**COMMANDER 114 SERIES
SERVICE PUBLICATIONS**

The following is a numerical list of all active Service Bulletins.

SERVICE BULLETIN NO. SB-114-1

AILERON CONTROL CHAIN REROUTING

Figure 7.

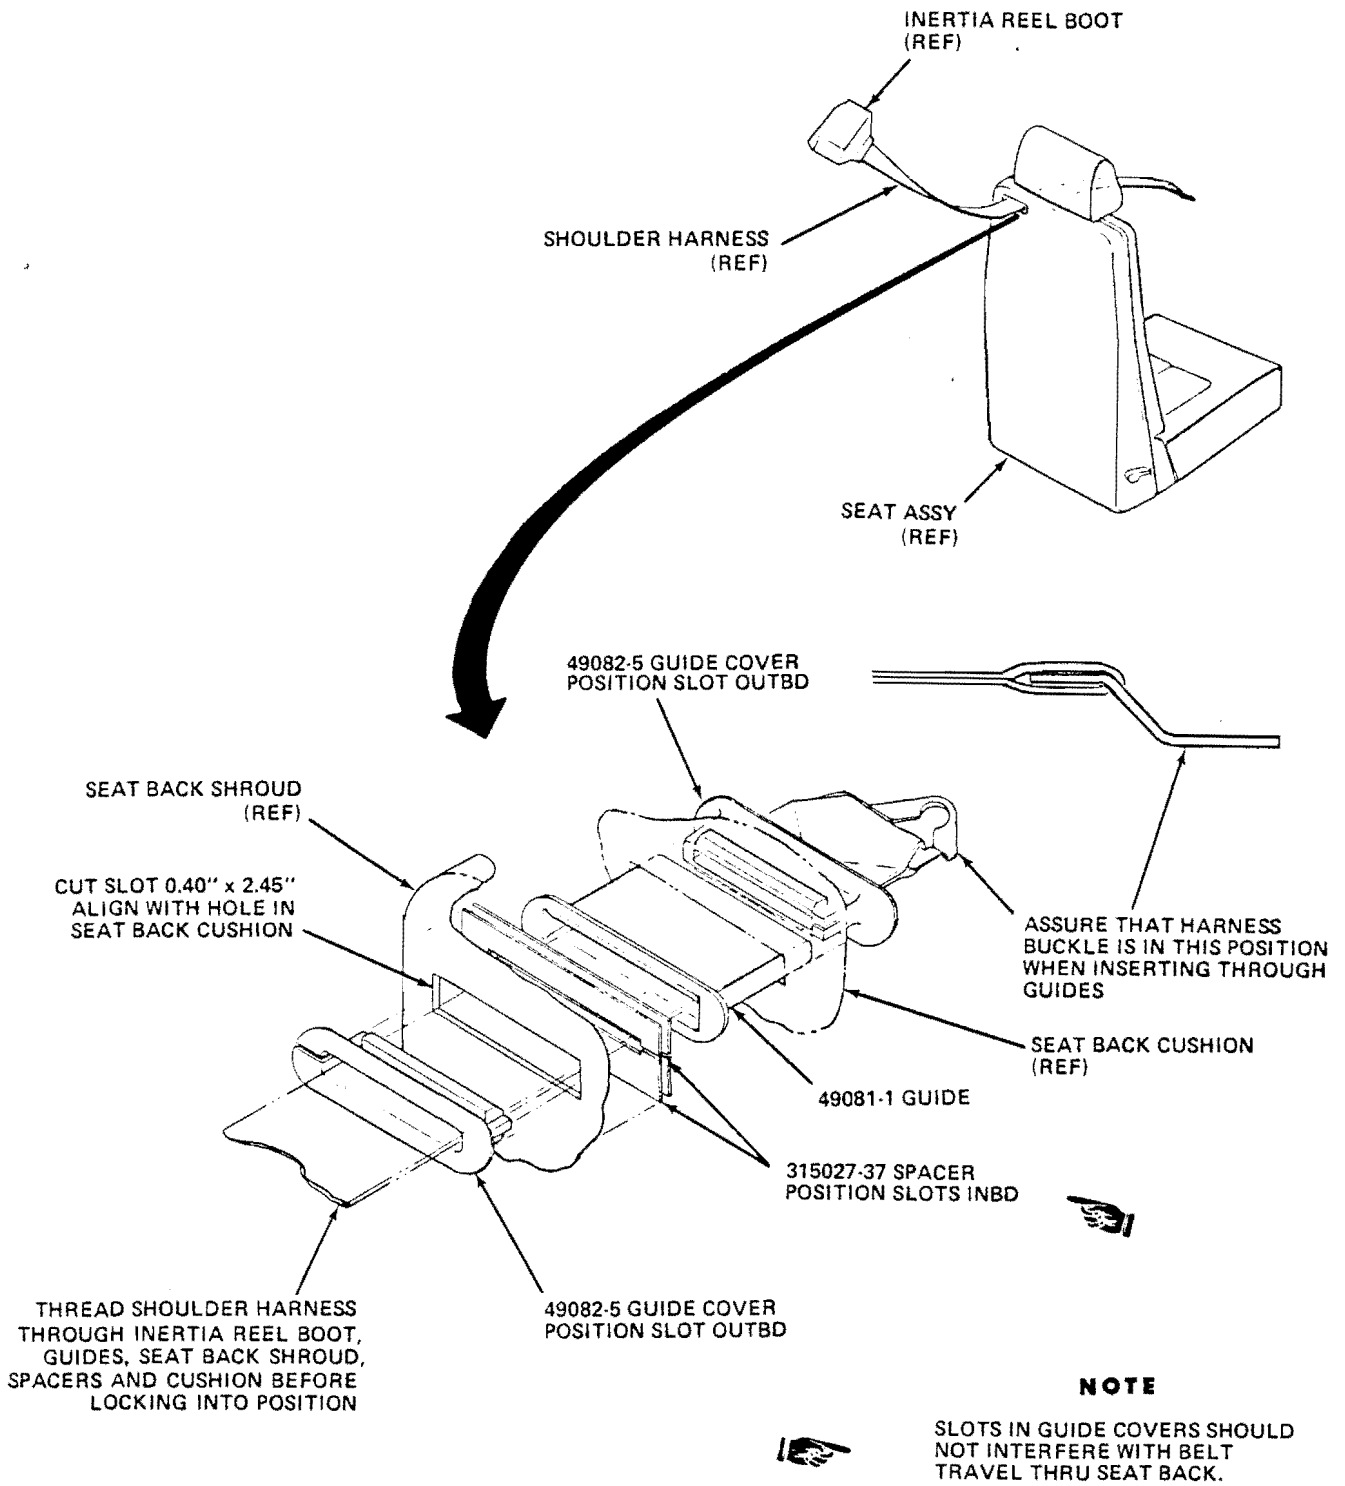
- a. Remove boot from shoulder harness reel assembly (refer to Figure 7).
 - b. Remove and discard existing AN4-6A bolt and NAS43HT4-16 spacer that attach shoulder harness reel assembly.

- g. Reinstall seat back cushion and assure that shoulder harness is routed thru seat back as shown in Figure 7.
 - h. Install 49082-5 guide cover on forward side of seat cushion (refer to Figure 7).
 - i. Reinstall head rest on seat assembly.
3. Fill out and mail Compliance Card specifying that Part II has been accomplished.

Figure 1.

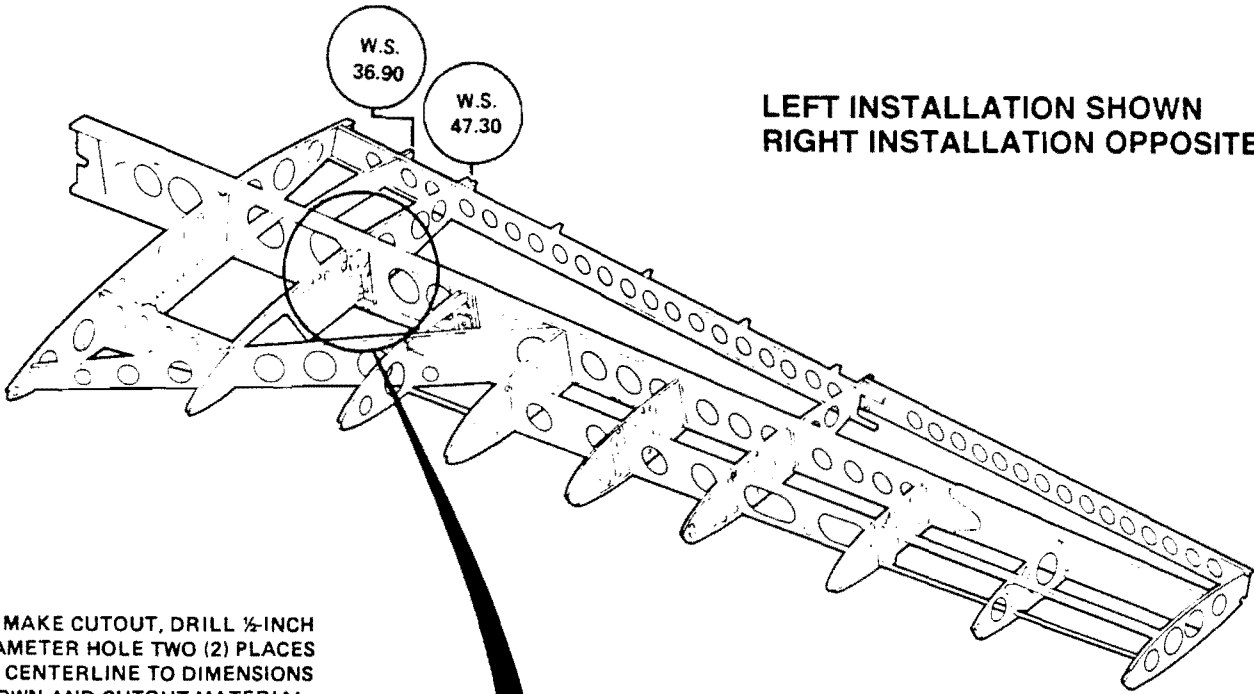
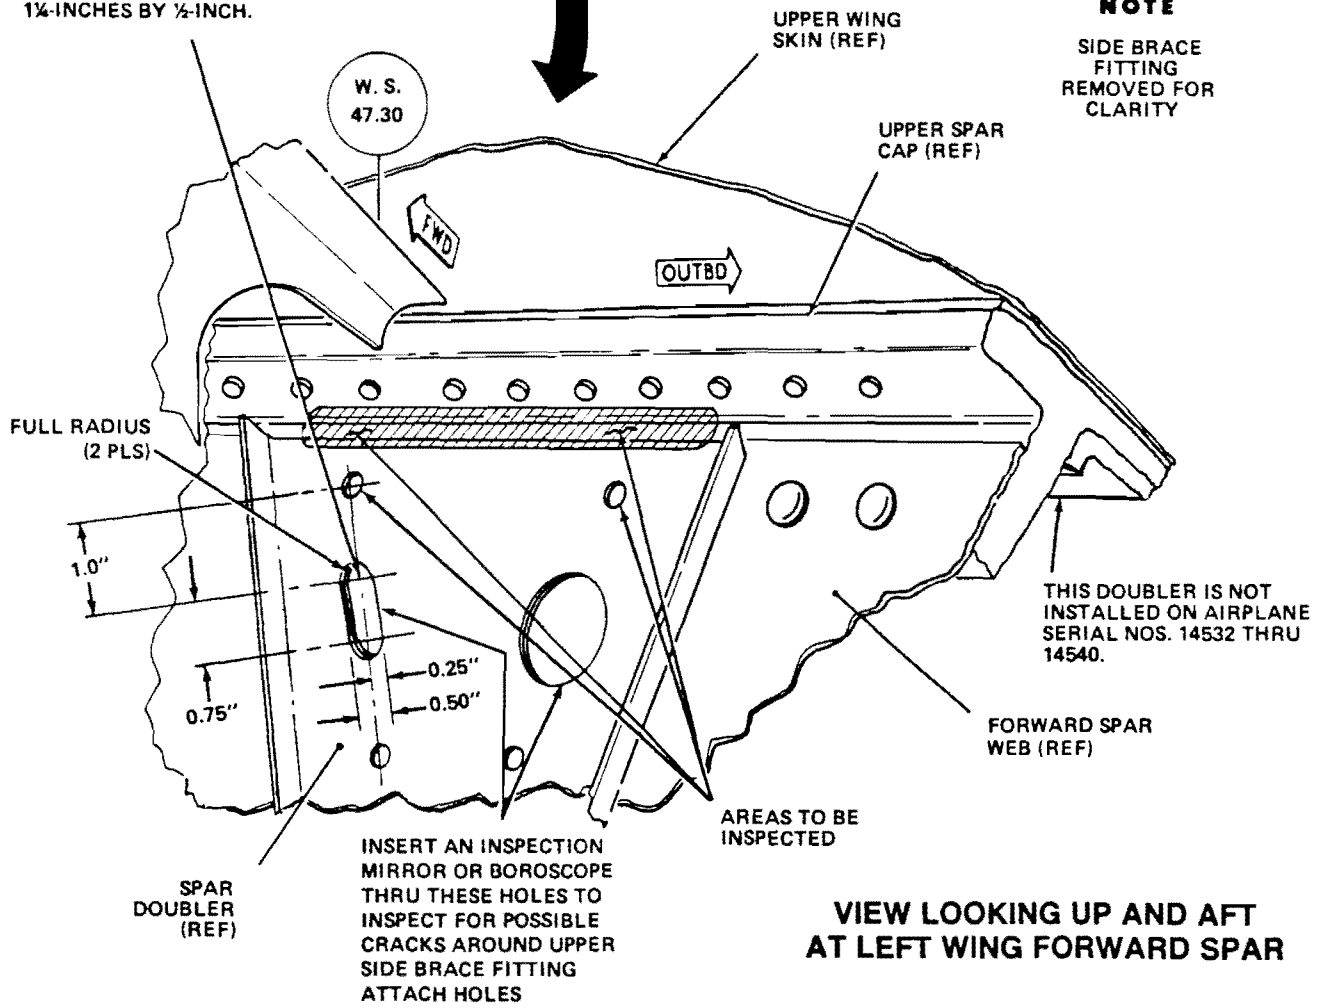
Care should be taken so as not to damage hydraulic lines when making cutout in step 6. When making cutout, dimensions shown in Figure 1. must be followed very closely so as not to cut into spar cap flange.

6. If necessary to facilitate inspection, make a cutout in side brace fitting doubler and in spar web to be used as an inspection hole as shown in Figure 1. Using an inspection mirror and flashlight or boroscope, inspect side brace fitting upper attach holes for cracks around holes in upper spar cap. Inspect aft side of spar cap (refer to Figure 1).

TO MAKE CUTOUT, DRILL 1/2-INCH DIAMETER HOLE TWO (2) PLACES ON CENTERLINE TO DIMENSIONS SHOWN AND CUTOUT MATERIAL BETWEEN HOLES. DEBURR ALL ROUGH EDGES. CUTOUT TO BE 1 1/4-INCHES BY 1/2-INCH.

Figure 1. Seat Locking Mechanism

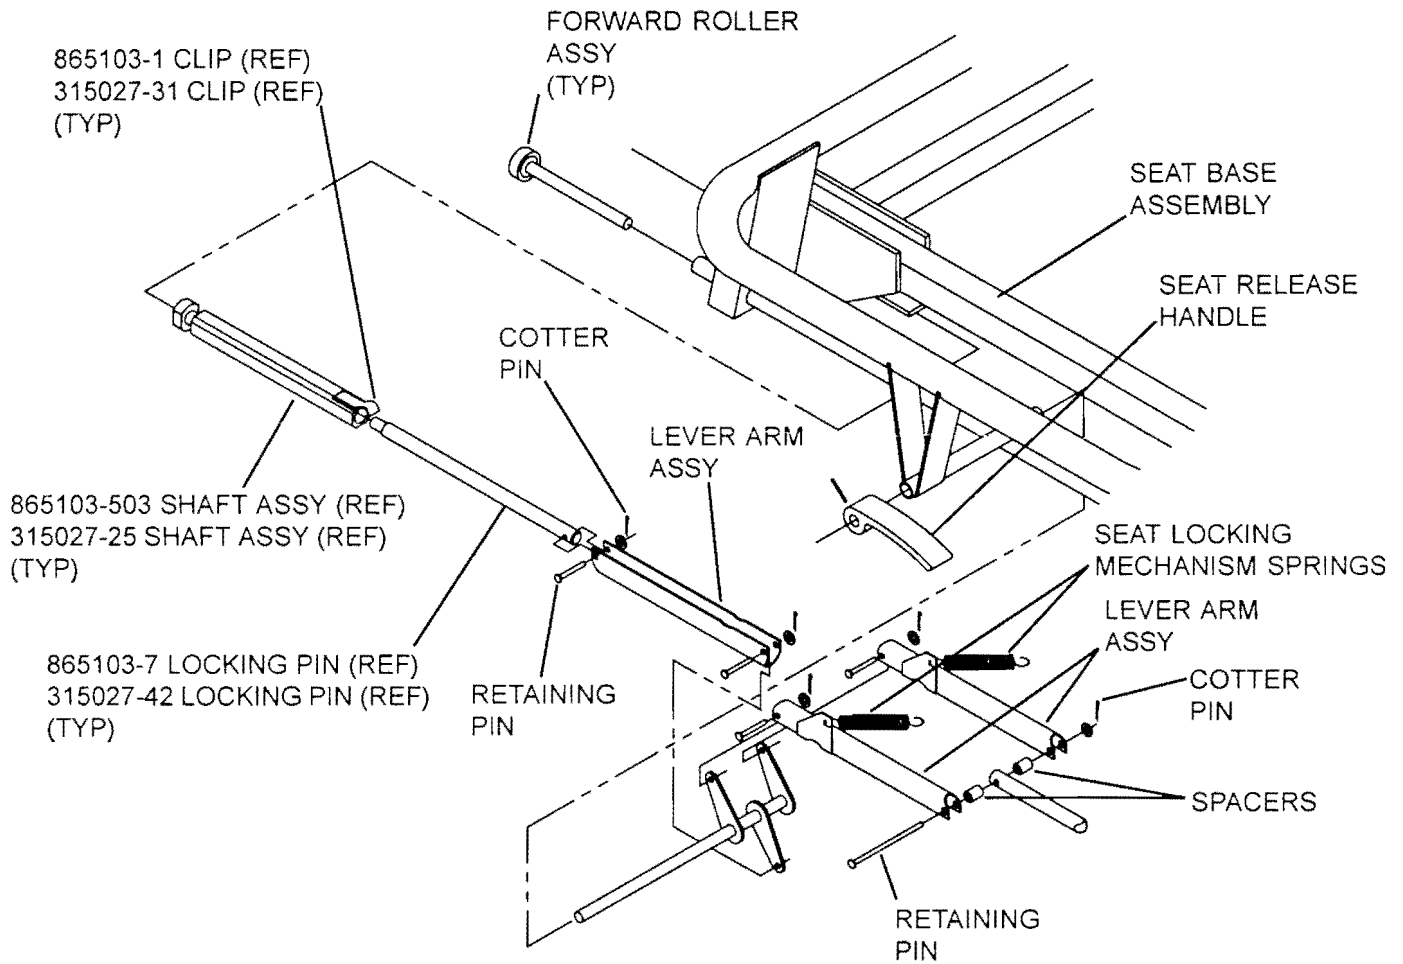
- a. Disconnect both seat locking mechanism springs from the Seat Base Assembly. (Refer to Figure 1.)
- b. Remove the cotter pins, retaining pins, and spacers at the two 865103-7/315027-42 locking pins. (Refer to Figure 1.)
- c. Position the 865103-503/315027-25 Shaft Assemblies in the locked position so that in the locked position, the 865103-1/315027-31 clip rides on the flat of the 315026-9 tube at the .24 dimension, shown in Figure 2. The curve of the clip may be adjusted to achieve the 90° dimension by carefully bending the curved end of the clip. After any adjusting of the clip, verify that the .06 minimum and .460 minimum dimensions are met.

Figure 1.
Left Wing Shown
Fuel Port Flap Valve Removed for Clarity

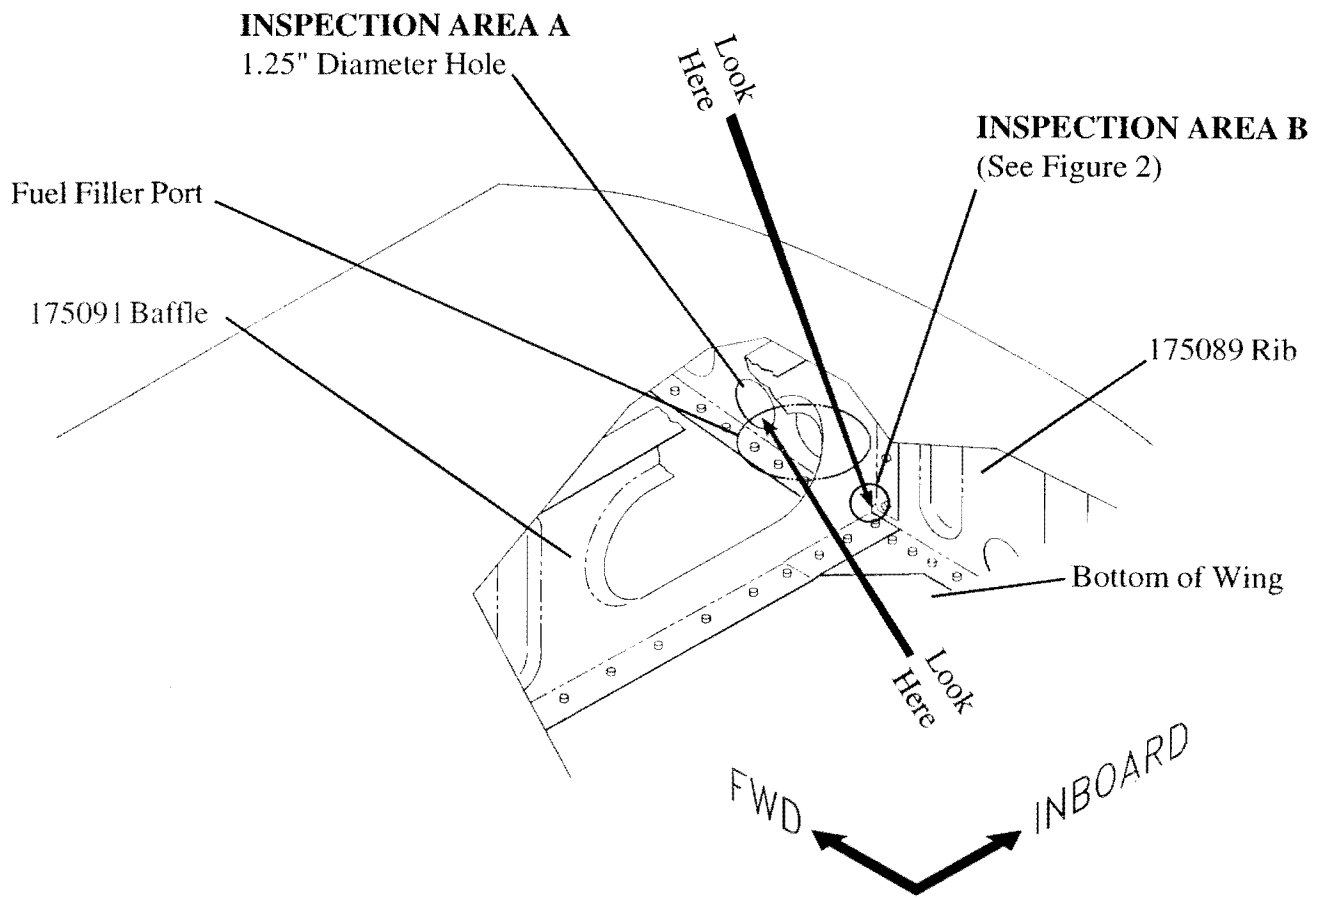
1. Uncap the fuel filler port and push the flap valve down and forward as far as possible.
2. Refer to Figure 1, Inspection Area A. Using a flashlight, look down into the fuel tank through the fuel filler port and as far forward as possible past the 175091 Baffle. Inspect the 175089 Rib for a 1.25 inch diameter hole. If there is a 1.25 inch diameter hole in the rib, recap the fuel filler port and proceed to the RECORD COMPLIANCE section of this Service Bulletin. If there is no 1.25 inch diameter hole in the rib, proceed to PART II: INSPECTION OF THE 175091 BAFFLE.
